Access Compliance Report Public Rights-of-Way (Curb Ramps)

Main Street: CANYON_VIEW_AVE Cross Street: N/A Location: S

ADA ID: RPRK220103113212 Ramp Type: Type 1 - Perpendicular Initial Pass/Fail: Pass Overall Compliance: No Severity Score: 25

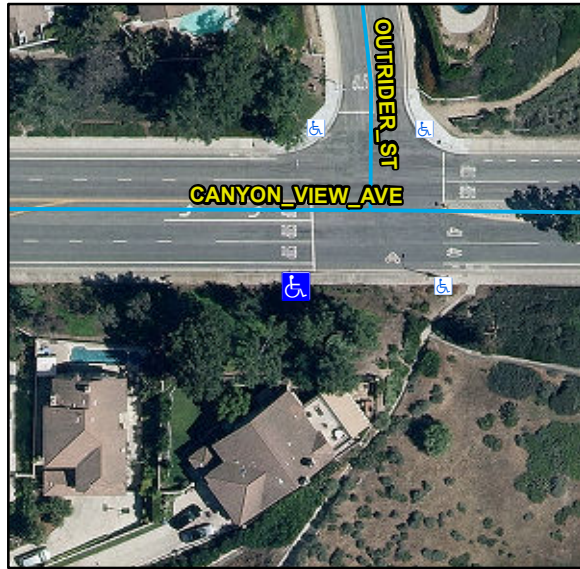
N/A	Ramp Inside Crosswalk 1	N/A	Yes	Ramp Inside Crosswalk 2	N/A
	Crossing 1 Slope (%)	0.7		Crossing 2 Slope (%)	N/A
	Crossing 1 Cross Slope (%)	0.5		Crossing 2 Cross Slope (%)	N/A
Yes	Gutter Ponding	No	No	Curb Slope	5.6
No	Gutter Lip Height (in)	0.25		Road Run Slope (%)	N/A
No	Gutter Run Slope (%)	5.3		Road Cross Slope (%)	N/A
Yes	Gutter Cross Slope (%)	1.1			
Yes	Overall Surface Condition: Acceptable		Yes	Perp Joint Present	Yes
	Cross Gutter Present?	No		Spandrel Present?	No
	Replace Cross Gutter?	N/A		Replace Spandrel?	N/A

Remove & Replace Entire Ramp. Remove & Replace Gutter.
